April 28, 2016

ISSUED FOR USE  
FILE: Y14103320-01.007  
Via Email: david@canadianzinc.com

**Subject:** Response to the Wildlife and Vegetation Information Requests for the  
Developer's Assessment Report, Environmental Assessment, EA1415-01 REV 02  
Proposed All Season Road Access to Prairie Creek Mine, NT

**Figure 1: Conservative and Projected daily haul truck traffic volumes**

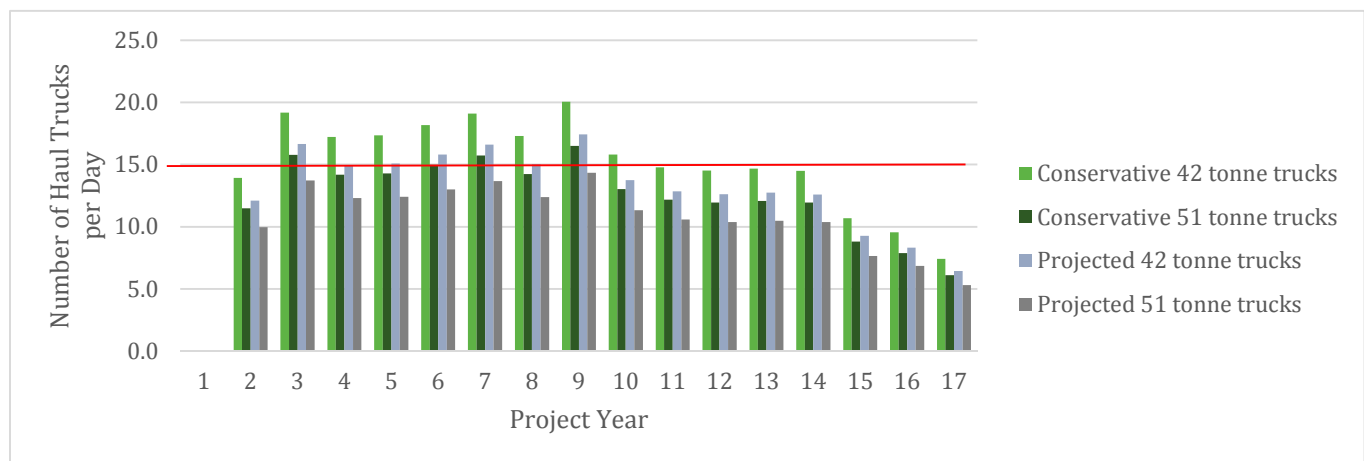
1. *Provide detailed information about sources of noise from the project including, but not limited to:*
  - a. *their locations, timing (including, but not limited to, the start and end dates, time of day, seasonality etc.); and*
  - b. *duration (how long the sound is emitted), frequency and magnitude (including, but not limited to, normal, peak, and cumulative decibel levels).*
2. *Provide an assessment of how far this noise can travel until it reaches background for individual sources and for any combination of noise sources, such as multiple noise sources from a borrow source.*
3. *Provide a consideration of how terrain, temperature, and weather may affect noise.*

*Provide a time series analysis of noise from the project. In other words, estimate how long a valued component can hear noise associated with the project. For instance, how long would a person be able to hear a haul truck and what is the interval between being able to hear the noise from one haul truck until the noise from another haul truck is audible? This must include considerations of terrain, weather, peak sound emissions (use of engine breaks for instance), and time of year.*

Recently Tetra Tech EBA received more details from CZN on the haul truck traffic volumes based on completion of an updated preliminary feasibility study. CZN provided greater detail to explain their statement that 'approximately' 15 trucks/day would be involved. CZN provided a range of truck numbers, up to 20 per day at a maximum, and Tetra Tech EBA was asked to consider if the details had any effect on the vegetation and wildlife and wildlife habitat impact assessment in the Report.

Tetra Tech EBA understands that haul truck traffic volumes are dependent upon the truck size (42.5 tonne or 50.3 tonne payloads), production year, and the length of the hauling period. As a result, the overall concentrate truck volumes will differ each year, with the annual traffic ranging from as low as 5.3 trucks/day to 20.0 trucks/day depending on conservative (192 hauling days) and projected (221 hauling days) estimates (Figure 1). Therefore, throughout the length of the project period, haul truck traffic volumes average between 10.9 to 15.3 trucks/day.

The environmental assessment was completed based on approximately 15 haul trucks/day throughout the entire project life (Graph 1, red line). Tetra Tech EBA regards the haul truck traffic volume modifications to be of a very minor nature and do not alter the predictions presented in the environmental assessment report.
